**DESIGN REVIEW BOARD/SIGN BOARD OF APPEALS REGULAR MEETING
THURSDAY, JANUARY 16, 2020 - 7:00 p.m.
WINNETKA VILLAGE HALL COUNCIL CHAMBERS – 510 GREEN BAY ROAD**

TO: DESIGN REVIEW BOARD
FROM: CHRISTOPHER MARX, AICP, ASSOCIATE PLANNER
DATE: JANUARY 10, 2020
SUBJECT: CASE NO. 19-36-DR: 966 GREEN BAY ROAD - CONSIDERATION OF
CERTIFICATE OF APPROPRIATENESS

966 GREEN BAY ROAD, WINNETKA | COMMERCIAL DEVELOPMENT

WEST ELEVATION (ALLEY)

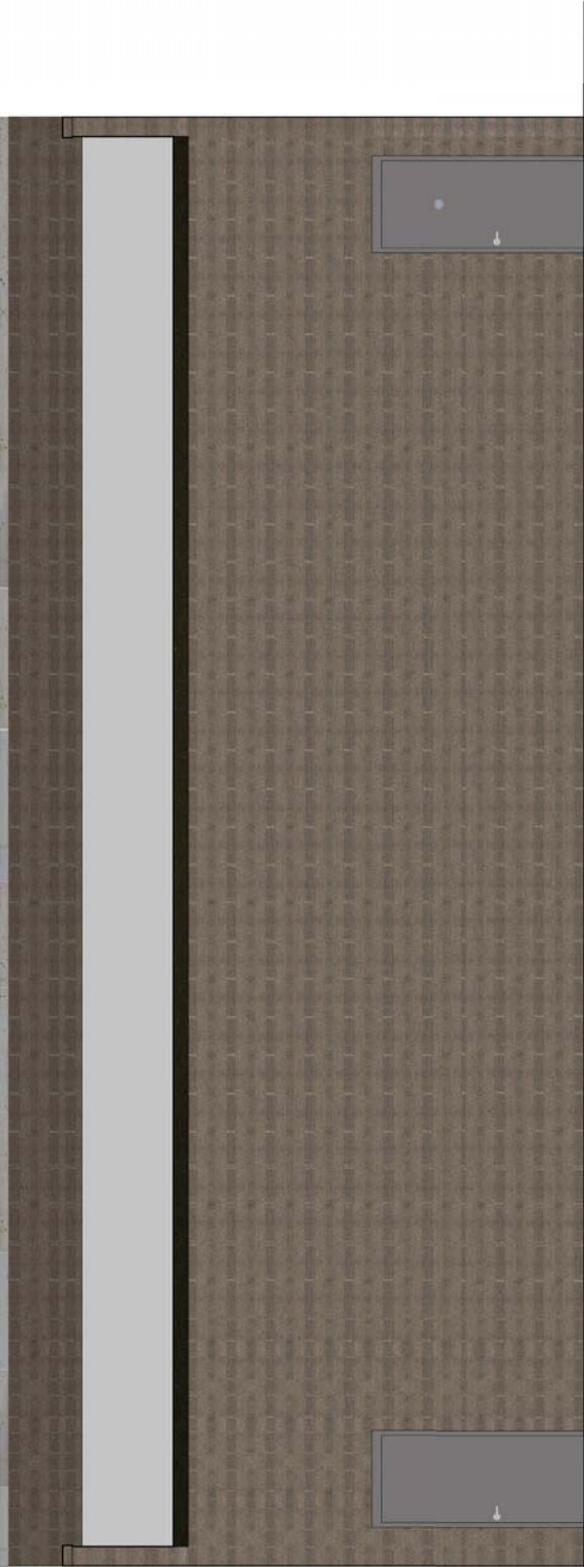
2. The rear façade, along the public alley, would contain a pattern of more traditionally shaped structural bricks called *Harvard Brik* that are a charcoal-gray color known as *Providence*. There would be an opaque door on each end of the façade that would serve as egress or service entrances.

- The Guidelines state that the façade material should be a traditional-looking modular brick, natural limestone, or cast stone. The proposed brick layer on the front facade would have a warm brown grey tone with minimal texture. The coping, upper band, and sill would be a stone-like material in a color to match the brick façade. The proposed brick layer on the rear façade would have a more functional masonry brick appearance in a charcoal-gray hue.

A Vinyl Window Graphics - 1.05 sq. ft.
Scale: 1"=1'-0"

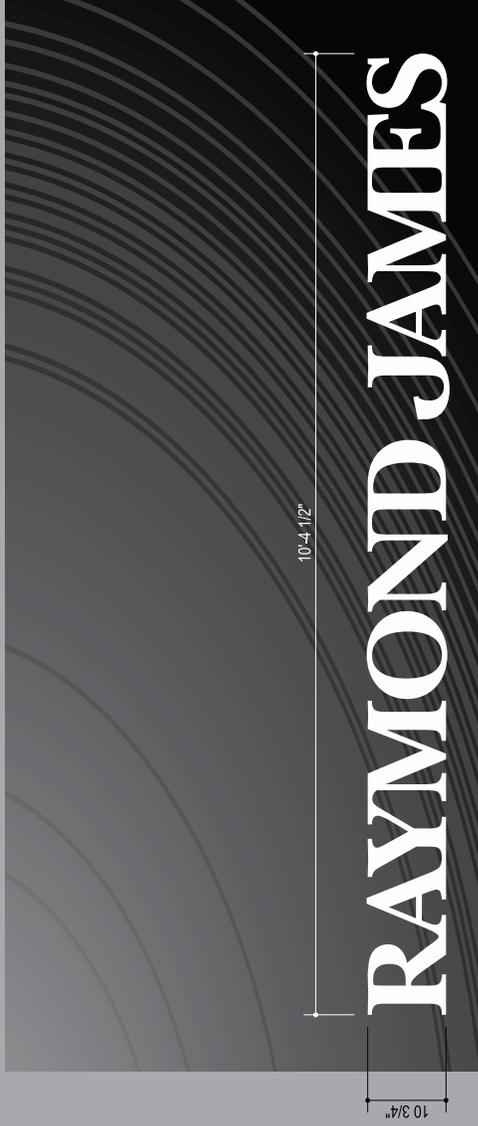
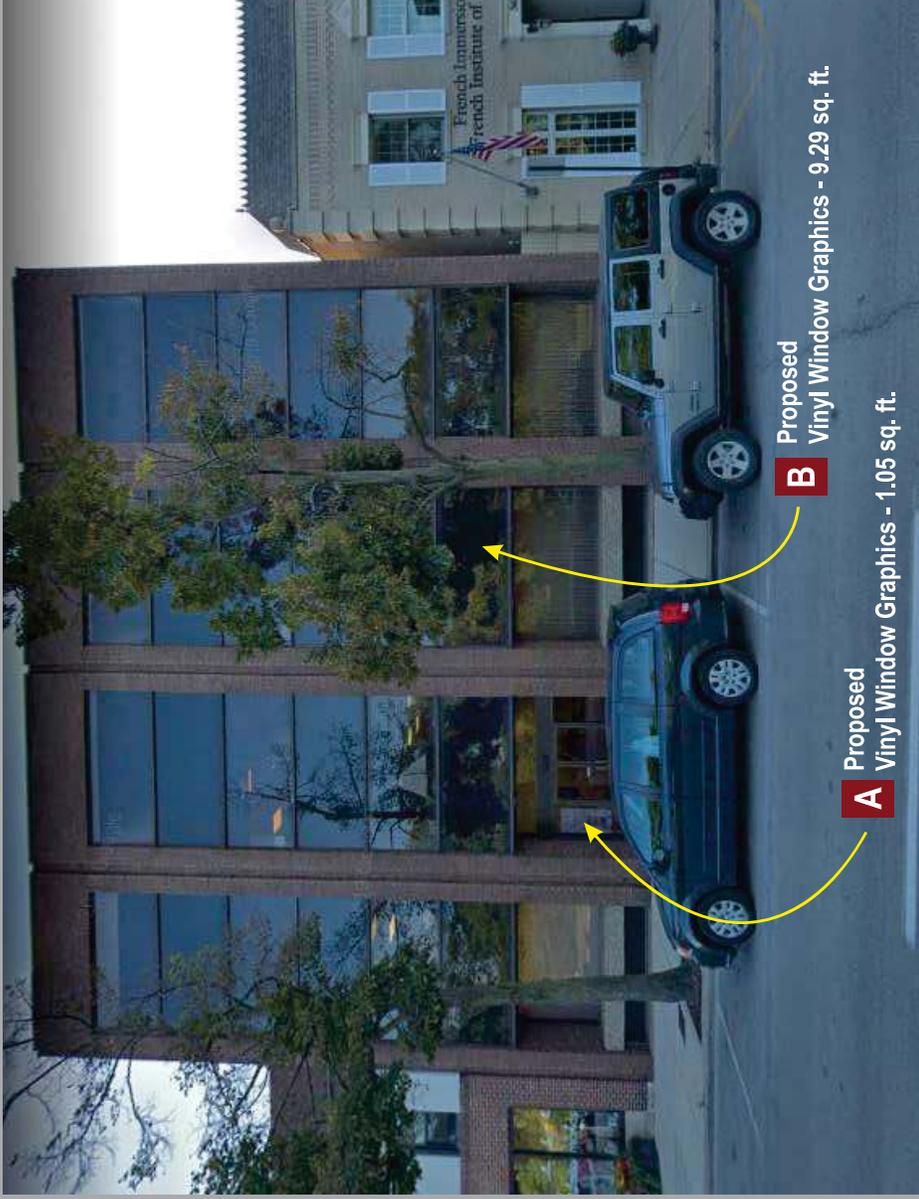
Area of window: 2.58 feet x 6.25 feet = 16.12 square feet
Maximum Permitted Window Sign Area: 1.61 square feet (10%)
Proposed Window Sign Area: 0.3 feet x 3.5 feet = 1.05 square feet (6.51%)
